## PROPOSED AMENDMENTS TO REGULATION N°13

This document amends document ECE/TRANS/WP.29/GRRF/2009/14. The changes compared to this latter document are marked in bold and strike-through characters.

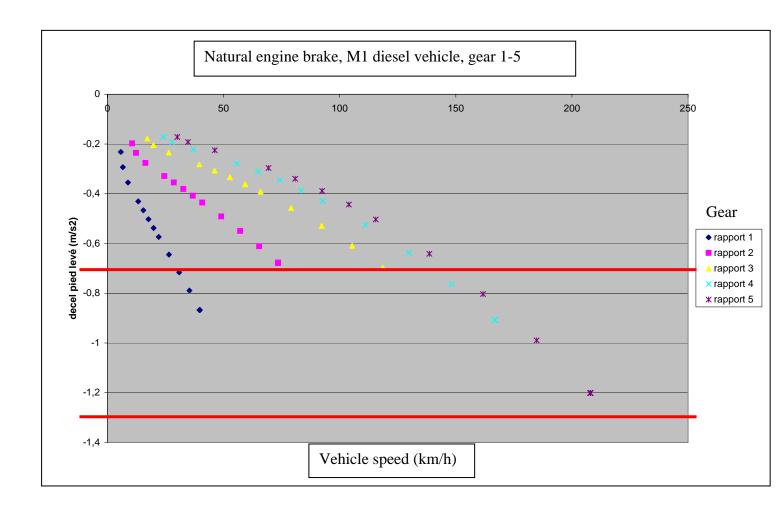
The graph below shows the decelerations achieved by a common M1 vehicle, unladen, diesel combustion engine, upon release of the accelerator control inside the whole possible speed range for each gear. The two proposed deceleration values (namely 0.7 m/s² and 1.3 m/s²) are indicated by the red lines. This graph clearly shows that the natural engine/rolling resistance deceleration is always below the required **generation** value (1.3 m/s²), and is nearly always below the lowest required **suppression** value (0.7 m/s²). The range between the lower and the upper value is necessary to avoid flickering of the stop lamps when the vehicle decelerates around the threshold value. This implies that the proposed amendments for the

regenerative braking won't have any adverse effect on safety because no stop lamp will illuminate at decelerations in the range of the natural engine brake of a common combustion engine.
